Permit No: 0512887  
Insp Area: 2  
Thos Bros: 336J3

Site Address: 7627 RUSH RIVER DR SAC  
Parcel No: 031-1440-024  
Sub-Type: NSFR  
REFLECTIONS @ RUSH RIVER LOT 5  
Housing (Y/N):

Nature of Work: MP 2034 STORY 8 ROOM SFR

Project: Reflections at Rush River

HOLDOWN REPLACEMENT DETAIL

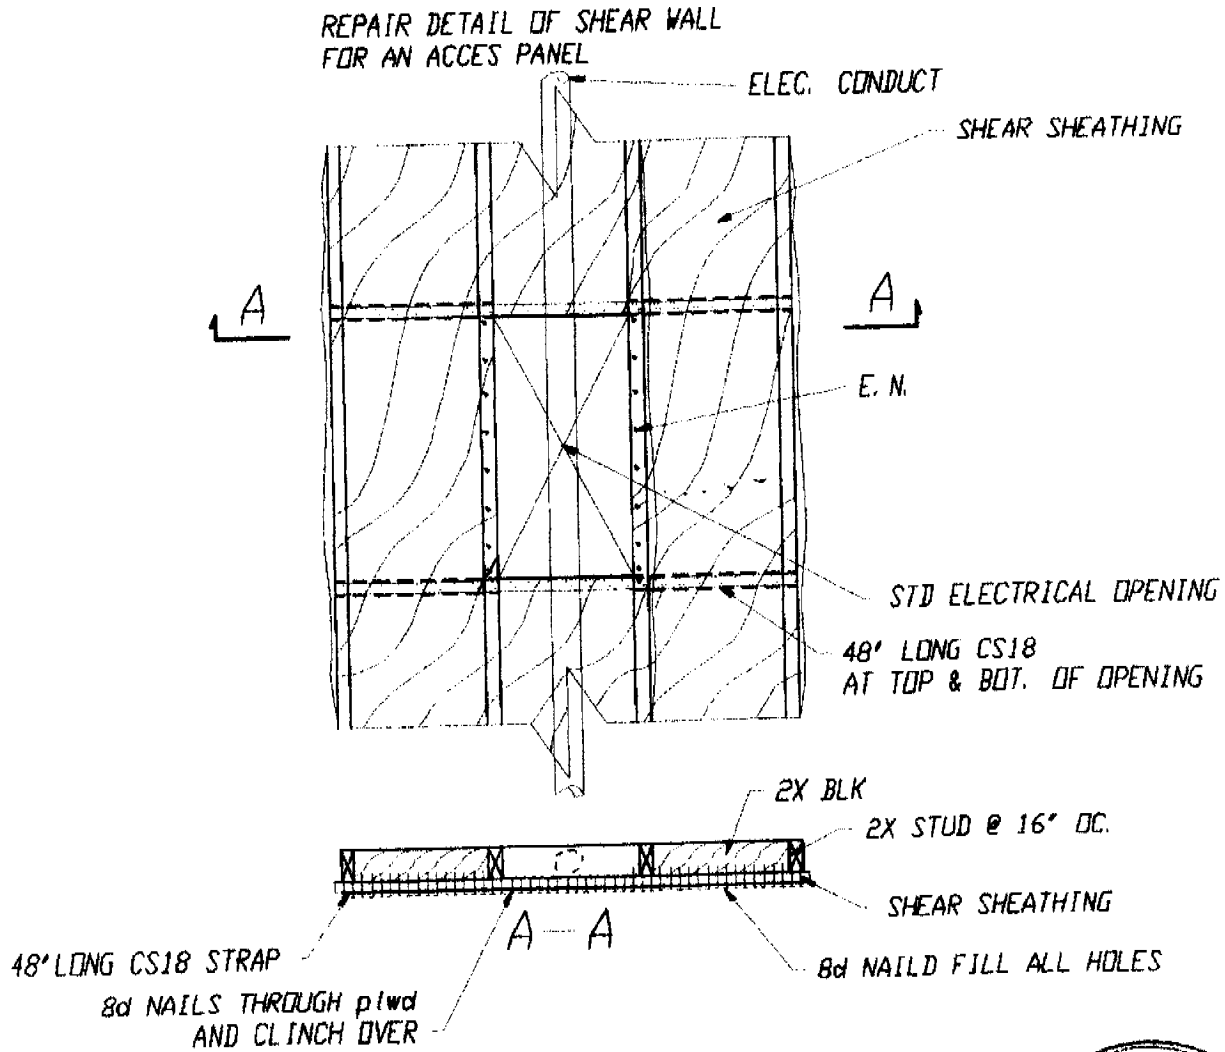
RE: Holdown replacement detail  
Project: Reflections at Rush River

(NOTE: THIS DETAIL CAN BE USED FOR MISSING/MIS-PLACED  
HTT22, HPAHD22, PAHD42 HOLDOWNS)

REMOVE DUST FROM HOLE/DIL-FREE  
COMPRESSED AIR, CLEAN AND BLOW OUT  
ALL DUST PRIOR TO APPLYING EPOXY
